Agenda Title: Approval of Change Order #9 with DN Tanks, LLC. for the Carter Hill Prestressed Concrete Tank and Seismic Upgrades Project

Contract Change Order (CCO) No. 9

Project: <u>Carter Hill Prestressed Concrete Tank & Seismic Upgrades Project</u>	Owner: <u>Coastside County Water District (CCWD)</u>	Owner's Contract No.: <u>CIP Number 21-07</u>
Contractor: <u>DN Tanks, LLC</u>		Date of Contract: <u>July 21, 2024</u>

Contract Change Order (CCO) #9 Summary
Carter Hill Prestressed Concrete Tank and Seismic Upgrades Project
 Coastside County Water District
 Half Moon Bay, California

RFI Number:	49.0	Issued Date:	01/14/2026
Project:	Half Moon Bay, CA (CCWD)	Current Action:	Open
Project Number:	2024-070	Return Required Date:	01/21/2026
	500 Lewis Foster Drive Half Moon Bay, CA 94019		
Description:	Control/Analyzer Panel Concrete Pad

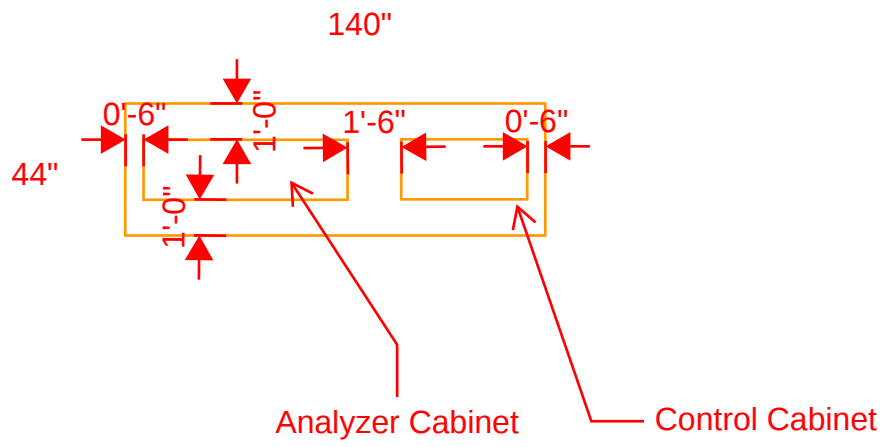
We request clarification on the design intent for the concrete pad supporting the analyzer cabinet and the control cabinet specifically, whether both cabinets are intended to be installed on one shared concrete pad or on two separate pads.

Based on the cabinet dimensions and the pad size shown on the drawings, installing both cabinets on a single pad may not be feasible. The analyzer cabinet measures approximately 5'-8" by 20 inches, and the control cabinet measures approximately 3'-6" by 20 inches, while the concrete pad shown on the drawings measures 4'-0" by 4'-5", which does not appear to provide sufficient area for both cabinets.

Please confirm the design intent and advise whether:

- ° Separate concrete pads are required, or
- ° The concrete pad dimensions should be revised.

The design intent is to have both cabinets sit on the same pad. Based on the cabinet dimensions provided, a pad footprint is revised to be 140" x 44". See next pages for details.

RFI Number:	49.1	Issued Date:	01/21/2026
Project:	Half Moon Bay, CA (CCWD)	Current Action:	Open
Project Number:	2024-070	Return Required Date:	01/28/2026
	500 Lewis Foster Drive Half Moon Bay, CA 94019		
Description:	Control/Analyzer Panel Concrete Pad

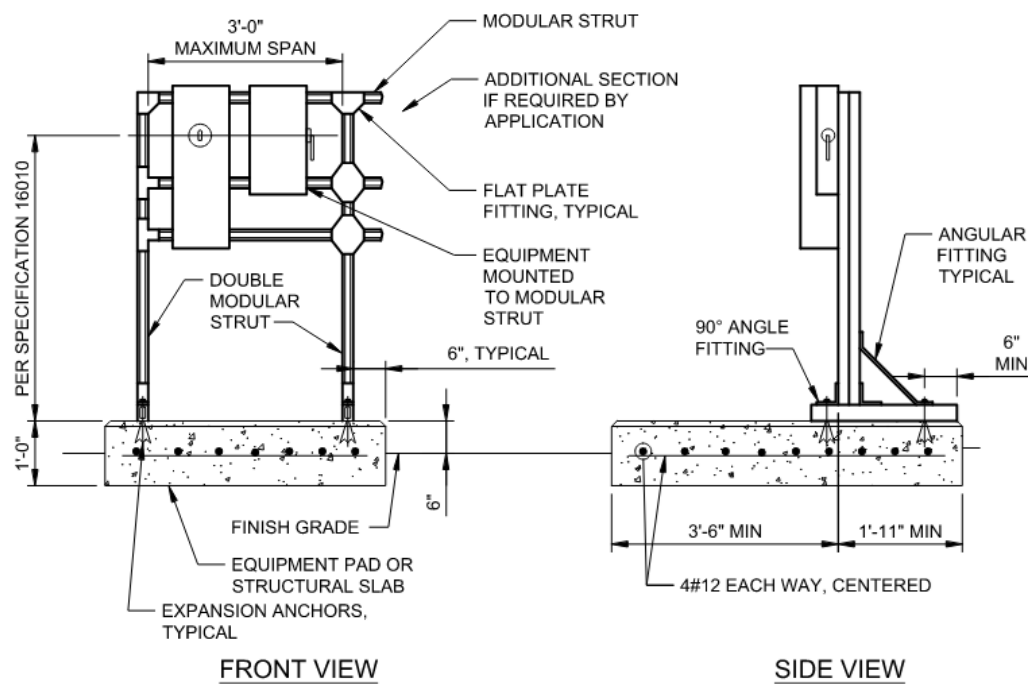
Would you please request reinforcement detail for the revised pad? Shall we follow the same detail as provided on the original plan drawing - see attached.

Please utilize the same equipment pad detail for depth and rebar.

SHEET
01C102

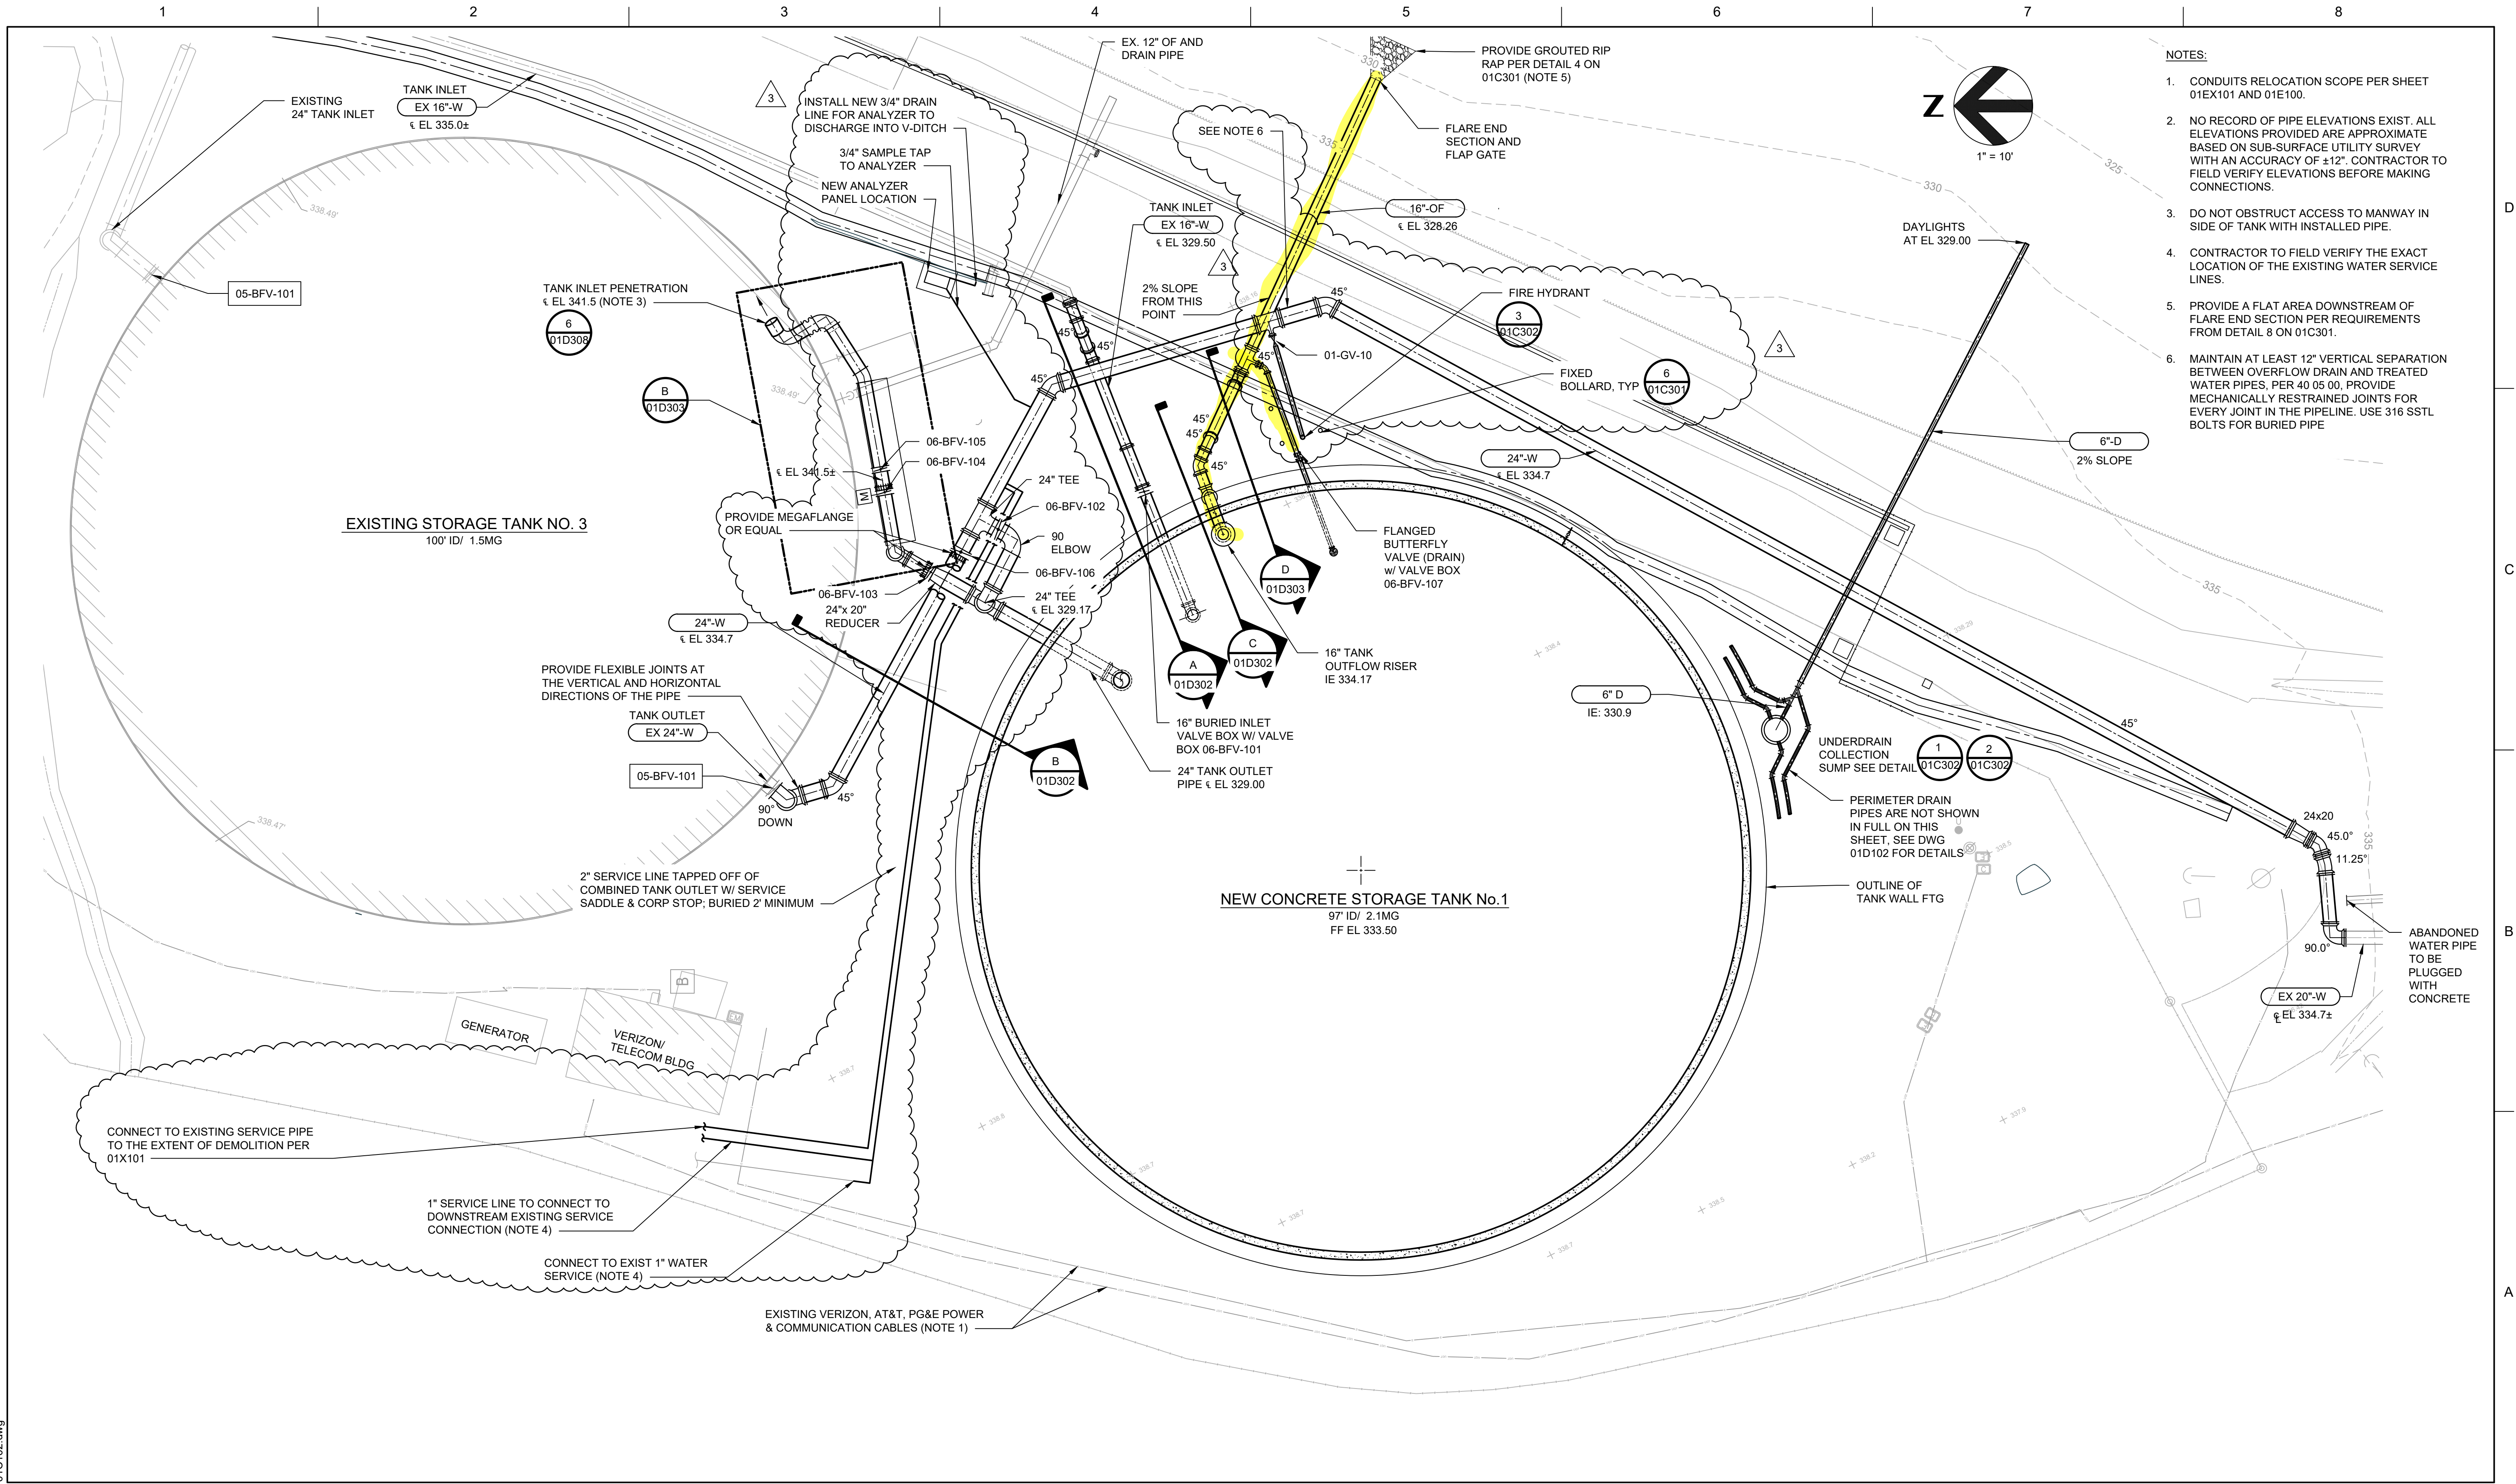
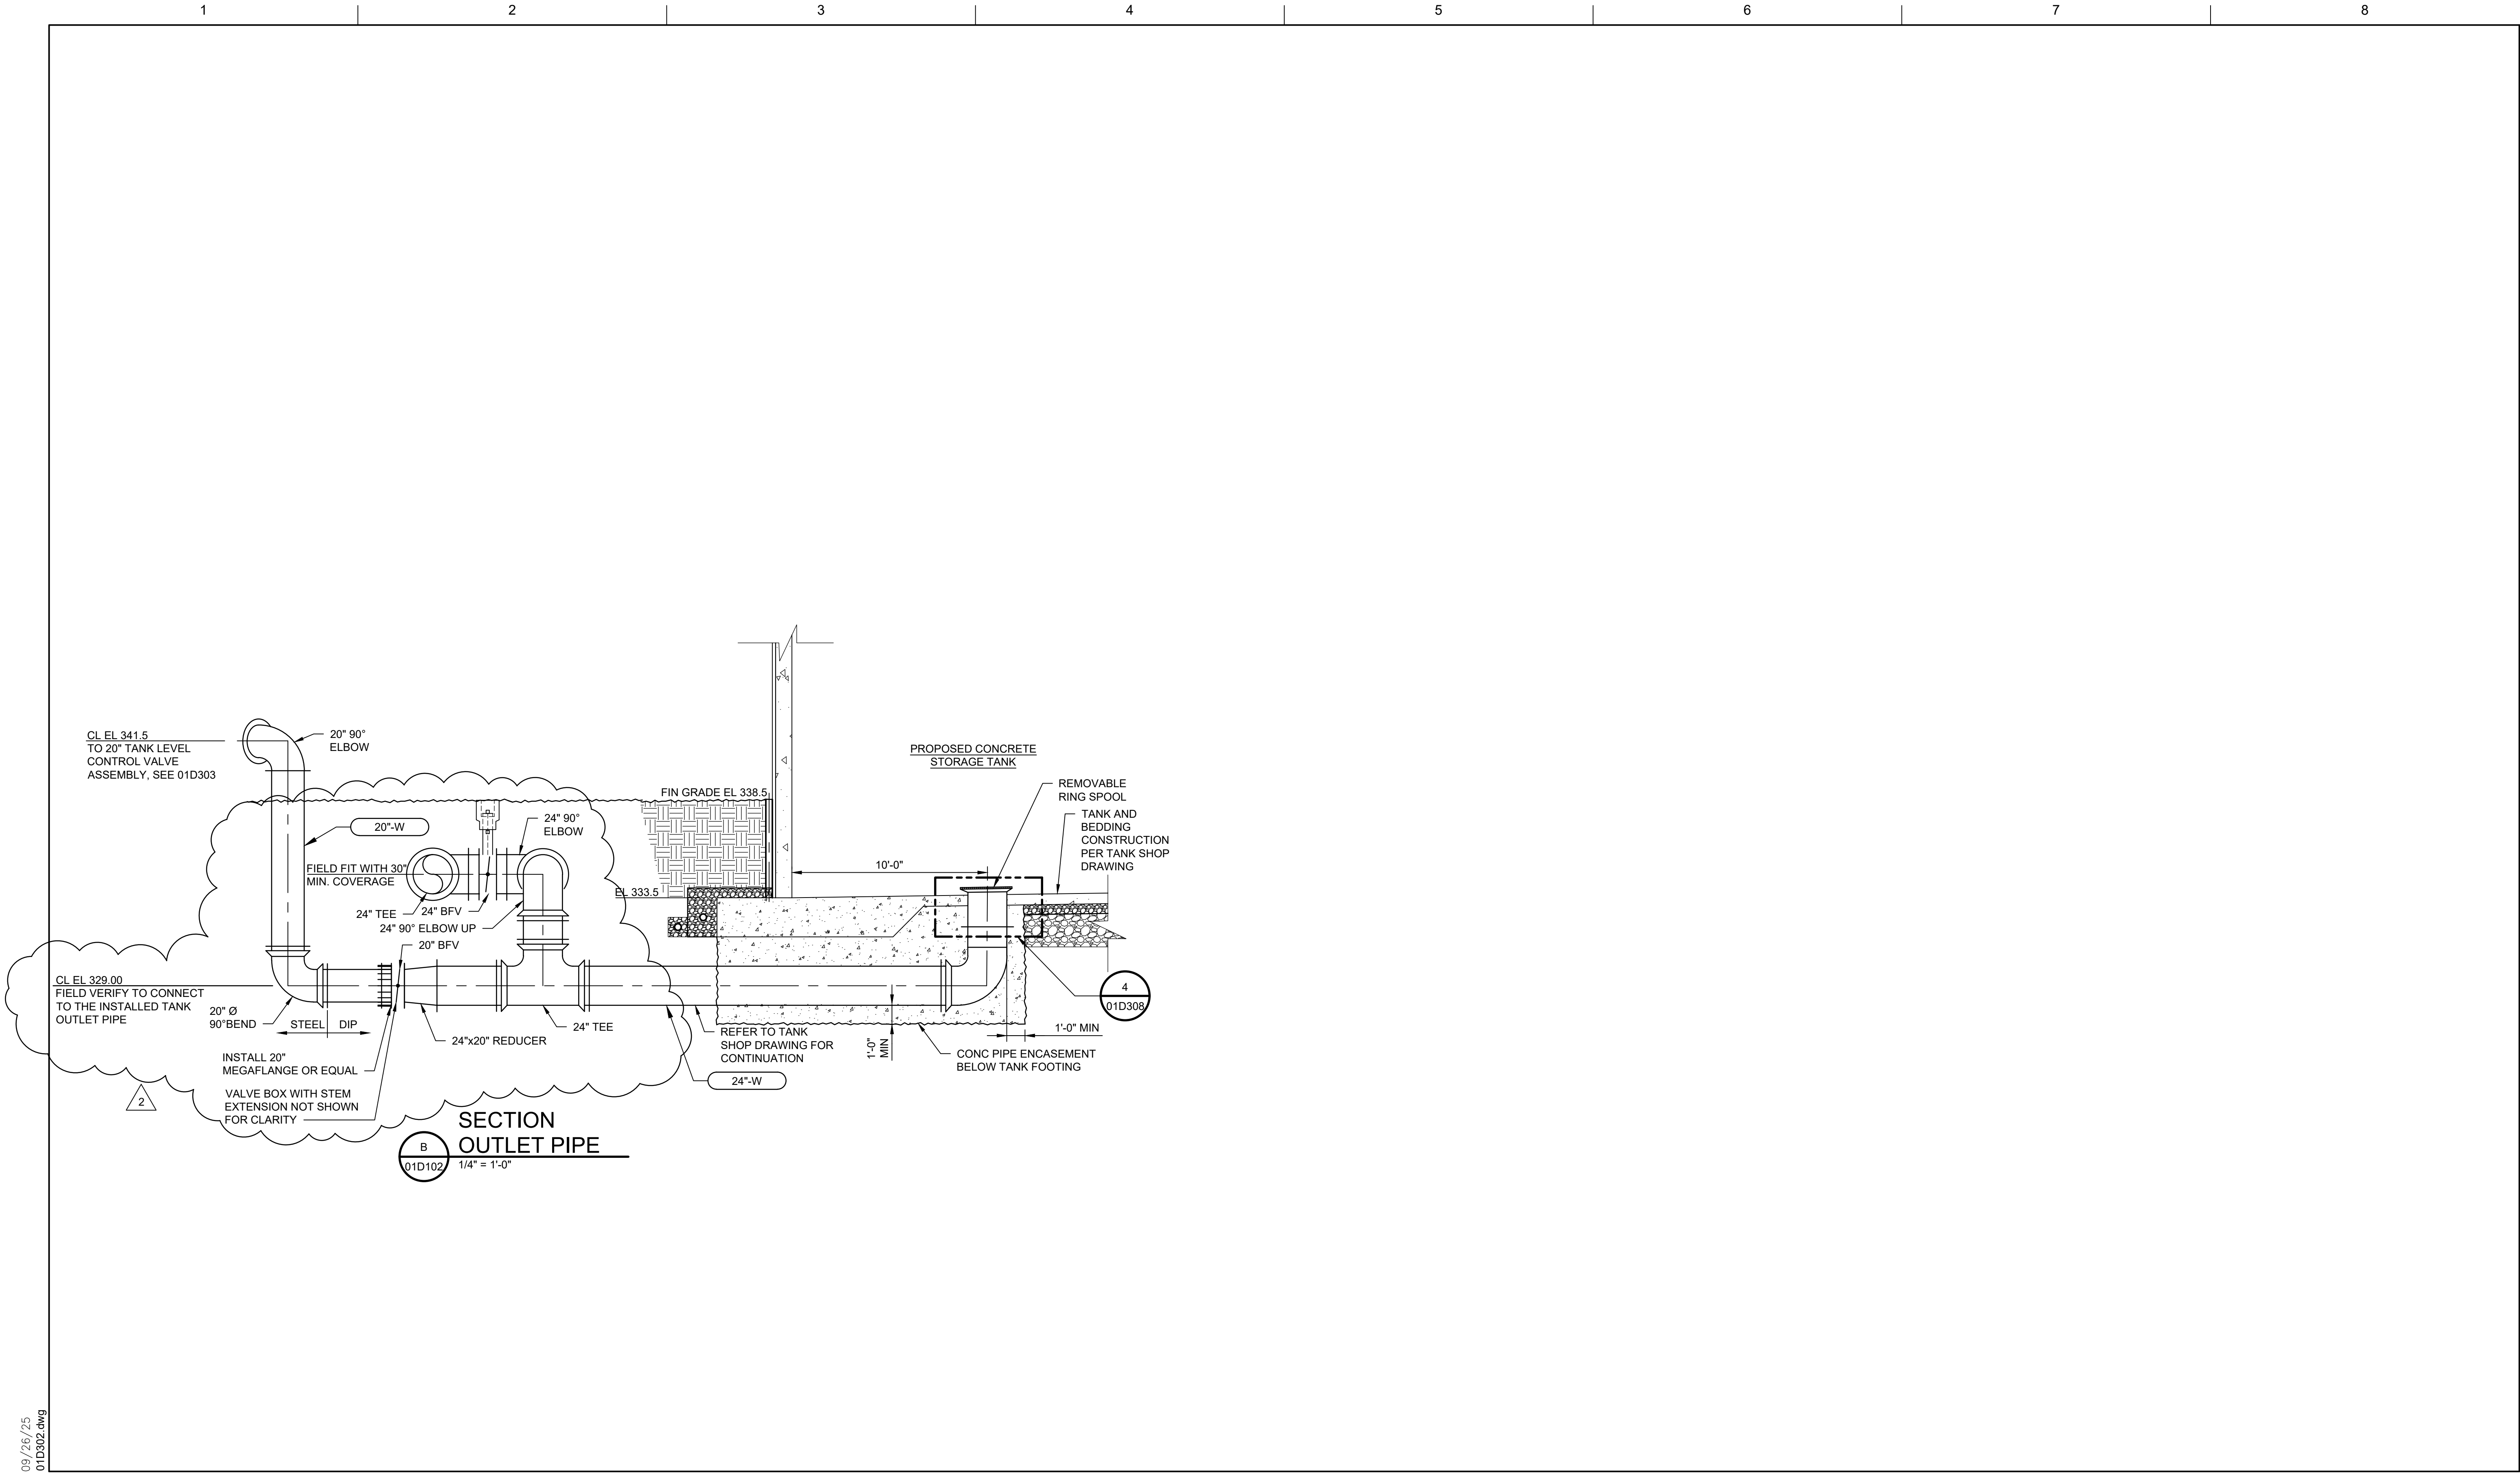
Per owner's request, the following yard piping design changes are issued. Changes are clouded in the attached for your reference.

1. Control piping configuration has been updated and the bypass of the control piping has been deleted.
2. Pipe material of the 20"-W has been changed from ductile iron to steel starting from the buried 20" elbow to the existing HMB Tank No. 3 as shown in the attached drawing set.
3. Pipe fitting design has been updated to accommodate the delivered 24" tees per RFI 35.
4. Fire hydrant (along with the tee) and analyzer panel locations have been relocated.
5. 2" service line tap-off locations have been updated.
6. Miscellaneous piping changes per attached drawings.
